# UNITED STATES PATENT AND TRADEMARK OFFICE

10/591,848

<b>Office Action Summary</b>	<b>Application No.</b> 10/591,848	<b>Applicant(s)</b> NIWA ET AL.	
	<b>Examiner</b> ANDREW T. KIRSCH	<b>Art Unit</b> 3781

## **DETAILED ACTION**

**Figs. 1, 2, and 4B of U.S. Patent No. 5,573,128 (Tsujiguchi et al. hereinafter)**

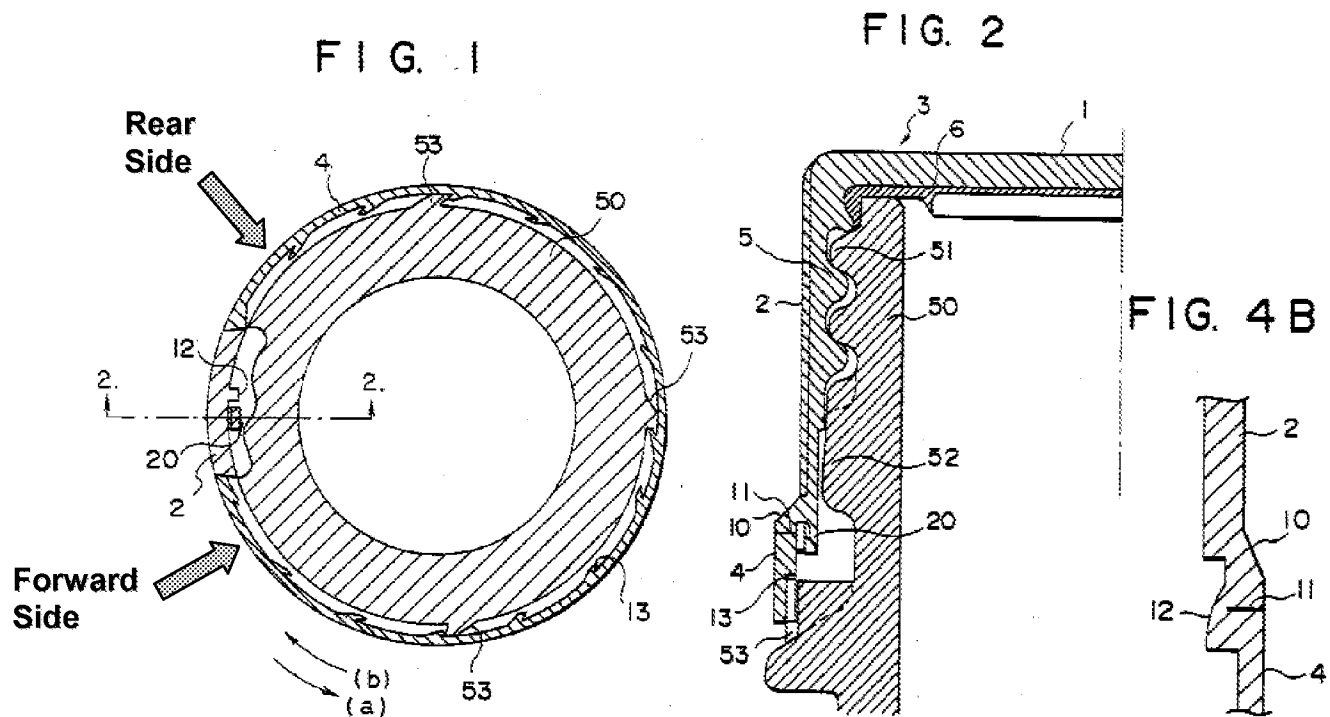
4. Claims 1-6, 8, 9, and 11 are rejected under 35 U.S.C. 102(b) as being anticipated by U.S. Patent No. 5,573,128 (Tsujiuchi et al. hereinafter).
5. In re claim 1, with reference to Figs. 1, 2, and 4B below, Tsujiuchi et al. discloses: An open/close cap which is screwed to a mouth portion of a pouring spout (50) of a packaging container and adapted to open the mouth portion, the open/close

cap comprising a cap body (3) screwed to an outer peripheral surface of the mouth portion and a band (4) attached to the cap body so as to extend in a circumferential direction thereof so as to be engaged with the pouring spout, wherein the band (4) is provided with at least one portion (12) for separating the band in the circumferential direction (direction normal to Fig. 1), end portions of the separated band is connected to each other by a connection piece (band is one piece, so inherently connected), which is to be cut off, at that one portion, a protruded portion (13) is formed to an inside of the band (4) so as to project toward the pouring spout (50), when the open/close cap (3) is rotated in an opening direction with respect to the pouring spout (50), a forward side (see Fig. 1) of the band between which the connection piece is snapped is rotated together with the cap body (3), and on the other hand, a rear side (see Fig. 1) of the band is prevented from rotating by engagement of the protruded portion (13) with a portion of the pouring spout (53), the connection pieces (12) are cut off by a stress of the band (4) generated by the engagement, and the band (4) is positioned below the lower surface (surface at line 11) of the cap body so as to be attached to the lower portion (10) of the cap body (3) by a coupling piece (12).

6. In re claim 2, with reference to Fig. 4B above, Tsujiguchi et al. discloses the claimed invention including wherein the coupling piece (12) connects the inner surface side of the band (4) and the lower surface of the cap body (3).

7. In re claim 3, with reference to Fig. 4B above, Tsujiguchi et al. discloses the claimed invention including wherein a contact preventing portion (10) having a diameter equal to at least an outer surface of the band (4) is provided for the outer peripheral surface of the cap body (3) so as to extend outward from the outer peripheral surface ("peripheral surface" interpreted as that of the cap body).

8. In re claim 4, with reference to the Figs. above, Tsujiguchi et al. discloses the claimed invention including wherein the contact preventing portion (10) is formed by extending at least a lower portion (10) in a vertical direction of the cap body (3).

9. In re claim 5, with reference to Fig. 2 above, Tsujiguchi et al. discloses the claimed invention including wherein a band shape maintaining member (13) for preventing crushing of the band in a radially inward direction through abutment of the inside portion of the band is disposed to the lower end of the cap body (3) in an inside portion of the band (4).

11. In re claim 6, with reference to the Figs. above, Tsujiguchi et al. discloses the claimed invention including wherein the band shape maintaining member (13) is composed of a plurality of projections (see Fig. 1) intermittently disposed to the lower end surface of the cap body (3) in a circumferential direction thereof.

12. In re claim 8, with reference to the Figs. above, Tsujiguchi et al. discloses the claimed invention including wherein the cap body (3), the band shape maintaining member (13), the band (4), the connection piece and the coupling piece are integrally formed by an injection molding process (column 6, lines 11-31).

**Fig. 3 of U.S. Patent No. 4,343,408 (Csaszar hereinafter)**

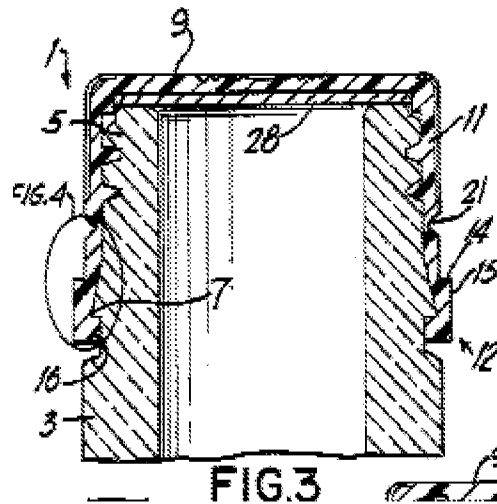
20. However, with reference to Fig. 3 below, Csaszar discloses a sealing cap with a frangible ring in which a band shape maintaining member (16) is an annular member (column 4, line 64) projected from the lower end of a cap body (note that the band is considered as the lower end of the cap body).

21. Therefore, it would have been obvious to have modified the band shape maintaining member of Tsujiguchi et al. to be annular in shape (a continuous ring) as taught by Csaszar. Such a modification would have been obvious for the purposes of increasing the lateral rigidity of the band as well as blocking pilfer attempts as was known in the art at the time of the invention.

**Fig. 2 of U.S. Patent No. 5,415,307 (Kneer hereinafter)**

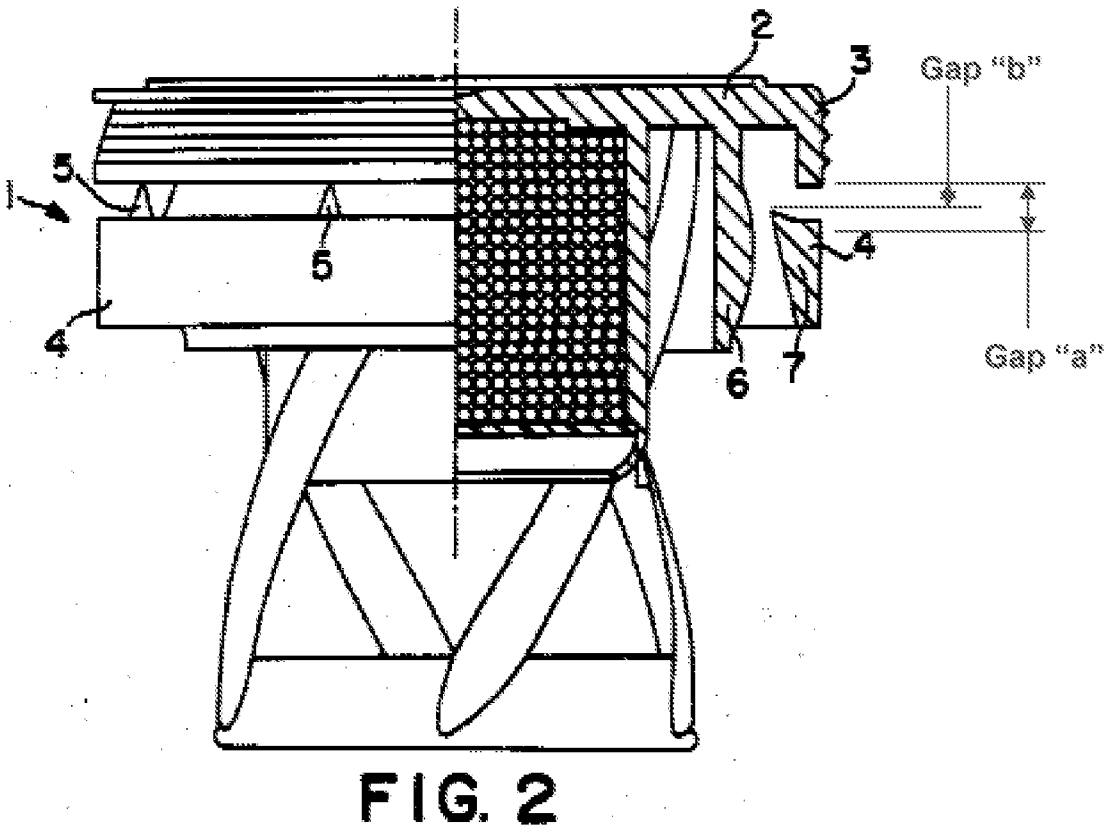
25. However, with reference to Fig. 2 below, Kneer discloses a cap body with a frangible member in which a band (4) is connected to a cap body by a coupling piece (5) so that a gap (gap "a") between the upper end of the band (4) and the lower end of

the cap body is formed to be larger than a dimension (gap “b”) between the lower end of a band shape maintaining member (7) and the lower end of the cap body (see Fig. 2).

26. Therefore, it would have been obvious to have modified the gap relationship between the band, cap body, and band shape maintaining member as stated with the relationship conveyed in Kneer for the purposes of simplifying the mold process by eliminating the secondary cutting operation called for in Tsujiguchi et al.
